Docket Number:	15-AFC-01
Project Title:	Puente Power Project
TN #:	213564
Document Title:	Nature Conservatory letter to CA Coastal Commission 9-8-16
Description:	Letter re Application for Certification - NRG Energy Center Oxnard LLC
Filer:	Darlene Burgess
Organization:	The Nature Conservancy
Submitter Role:	Public
Submission Date:	9/9/2016 11:49:40 AM
Docketed Date:	9/9/2016

Re: California Energy Commission's Application for Certification (15-AFC-01) – NRG Energy Center Oxnard, LLC, Puente Power Project, reviewed pursuant to Coastal Act section 30413(d)

Map 1: Current Coastal Flood Risk - City of Oxnard Electric Power Generation Facilities

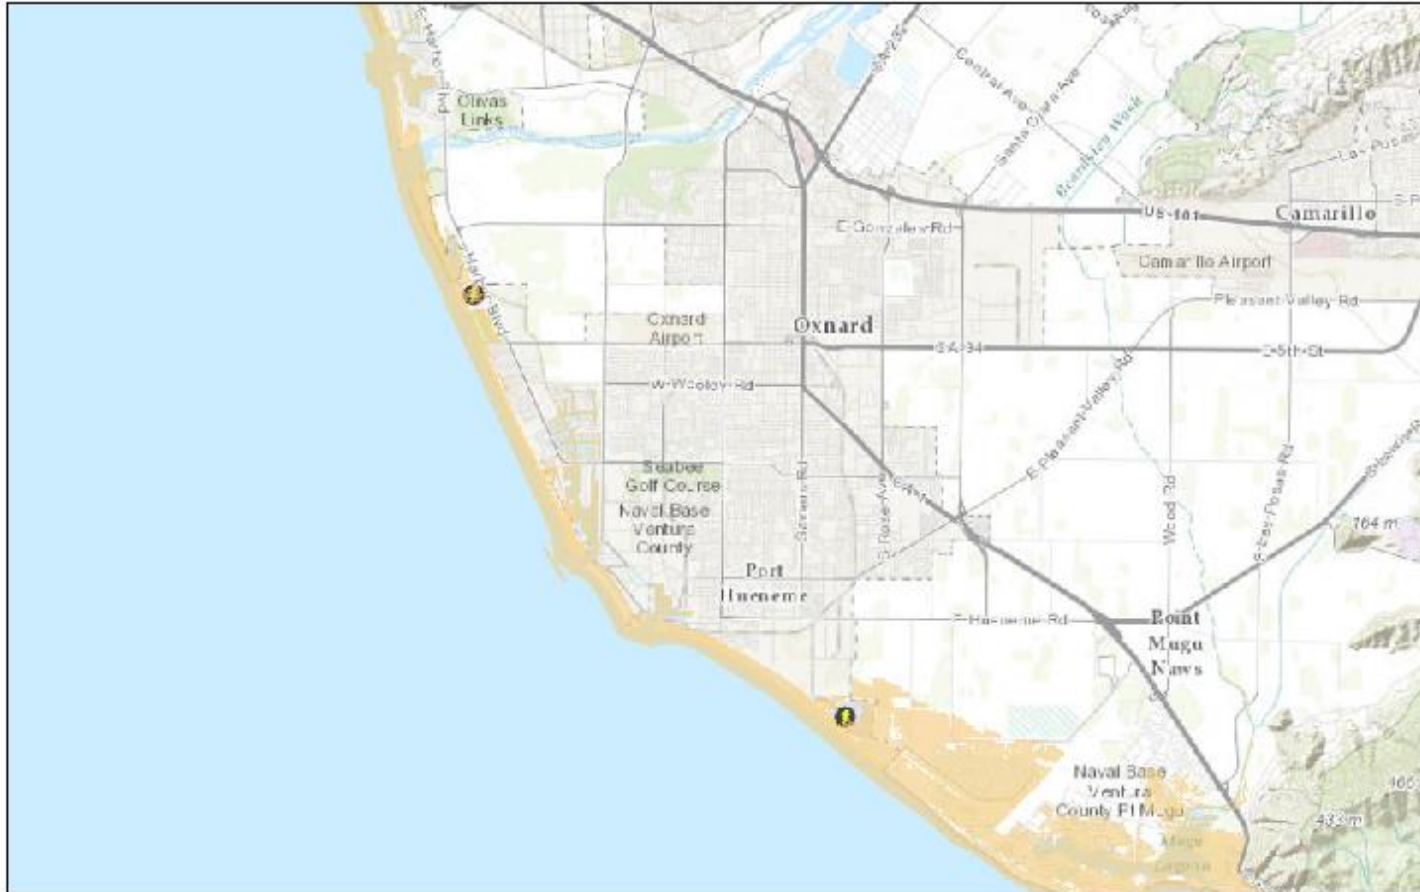
Results from the Coastal Resilience Ventura climate hazards model show existing risks in coastal Ventura County - and specifically at the proposed site of the Puente Power Project (Map 1) - that increase over time. These results also show significant risks of coastal erosion and flood hazards under various future climate scenarios at the site (Map 2). Accordingly, the CRV project’s science and analyses on the current and future flood hazards of the proposed Puente Power Project site are consistent with the findings in the Commission staff report.
